Submission made on behalf of the Elford Group with regard to the Aerotropolis Core Draft Precinct Plan.

Submission: Western Sydney Aerotropolis Precinct Plan

This submission has been prepared on behalf of the Elford Group with respect to the property at 320 Badgerys Creek Road, Badgerys Creek (**the site**), and in relation to the implication of the Draft Aerotropolis Precinct Plan for the Aerotropolis Core (**draft Precinct Plan**) and associated technical studies.

Figure 6. Open Space Network within the subject site under the Aerotropolis Core Precinct Plan

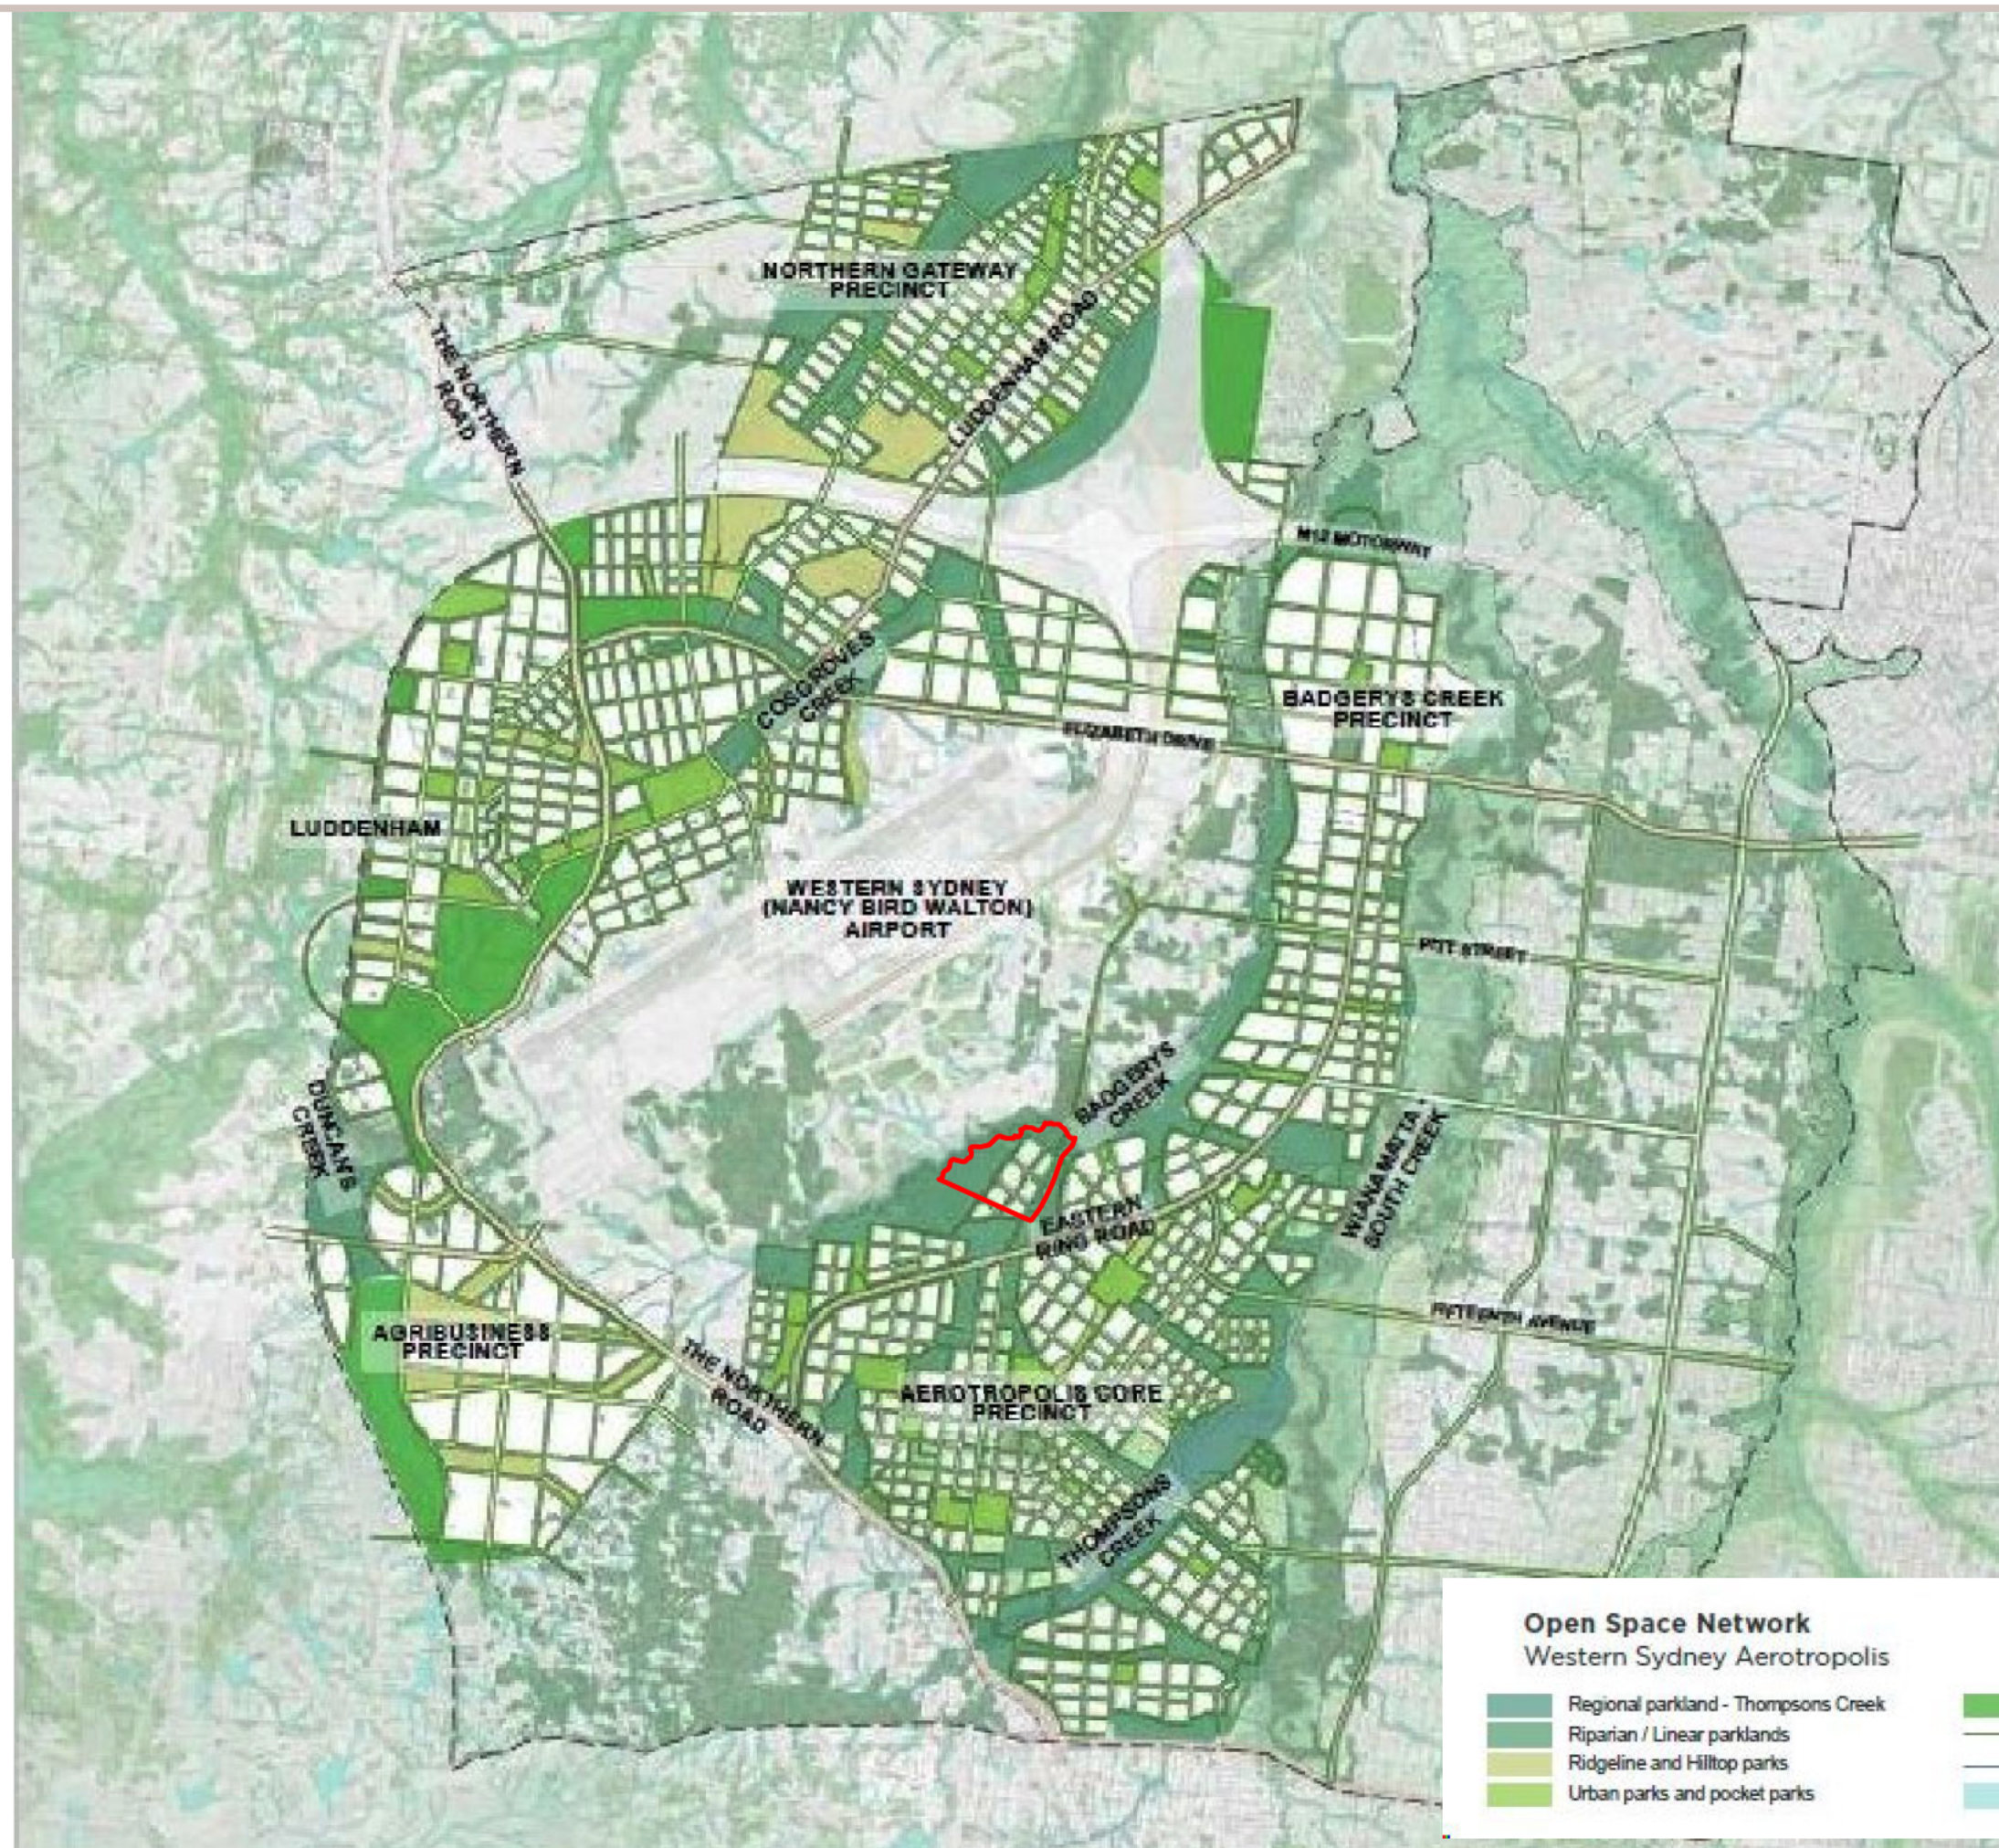
However, the area designed as riparian/linear parklands extends further south from the riparian corridor into land within the subject site that has been zoned as ENT under the Aerotropolis SEPP, thereby significantly reducing the amount of land allowed to be developed for that purpose (**Figure 6**). The proposed mapping of the riparian/linear parkland within the subject site is in contradiction with the ENT zoning objectives under the Aerotropolis SEPP, as the retainment of existing vegetation and revegetation of the area is not compatible with and will detract from the future commercial use of the subject site.

Figure 8: Aboriginal heritage sensitivity within the Aerotropolis (Subject Property circled in red) (sourced from Western Sydney Planning Partnership (2020, p. 5))

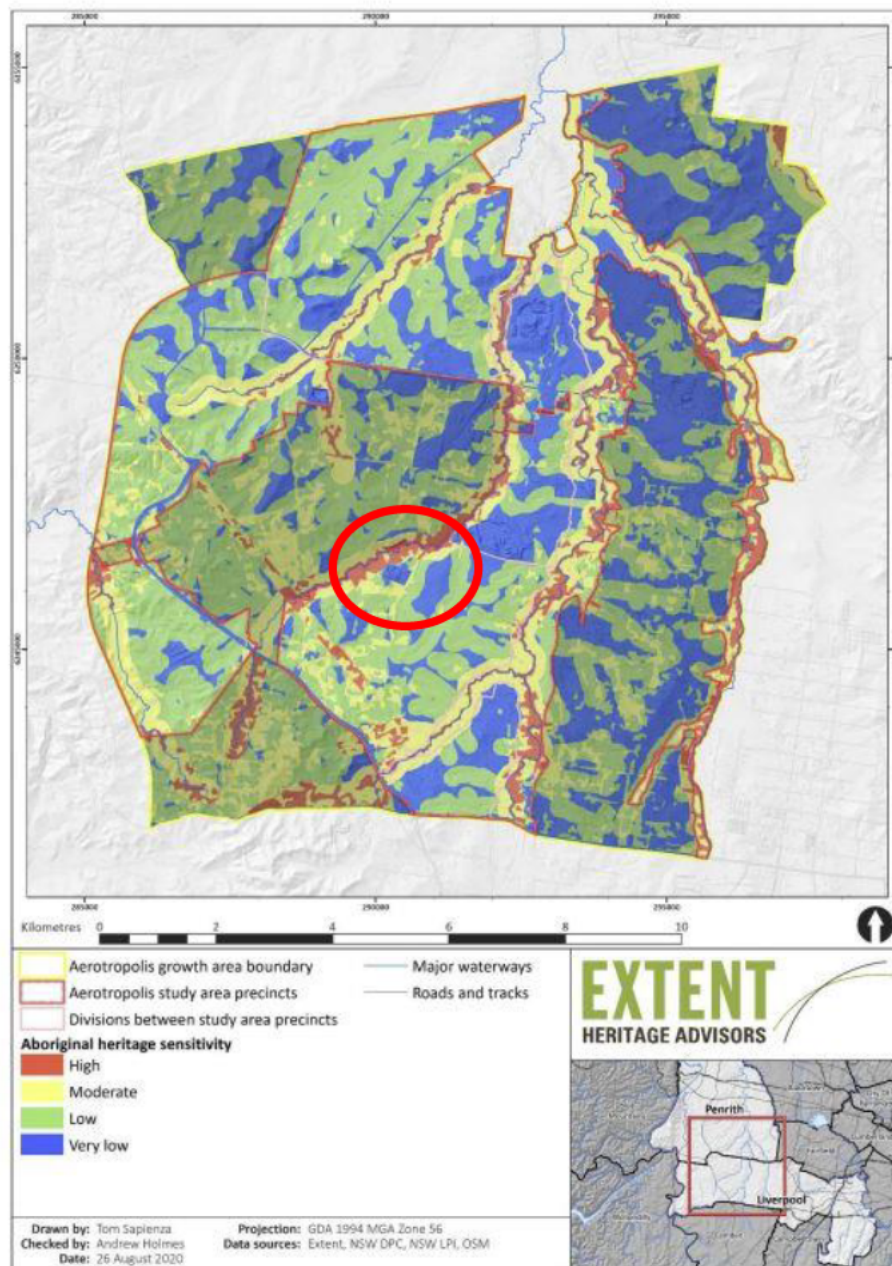
Extent (2020) does not appear to explain the process by which the Aboriginal archaeological sensitivity (refer to Figure 8) was determined. The high-level Aboriginal archaeological sensitivity mapping presented in Figure 8 shows the subject property as having very low to high archaeological sensitivity, with moderate to high sensitivity along Badgerys Creek. This is counter to Extent's (AHMS, 2014b) earlier site specific assessment of Aboriginal archaeological potential, where the terrace/levee landform to the east of Badgerys Creek was assessed as being moderate (see Figure 7).

A review of Figure 8 and Figure 7 indicates that the degree of the property that was assessed in 2020 to be sensitive is much greater as well.

The areas of sensitivity identified by Extent were based on a desktop assessment, and does not consider Extent's (AHMS, 2014b) earlier site specific assessment of Aboriginal archaeological potential (see Figure 7). It is recommended that Extent (2020) be revised to consider their previous Aboriginal heritage sensitivity/potential assessment.
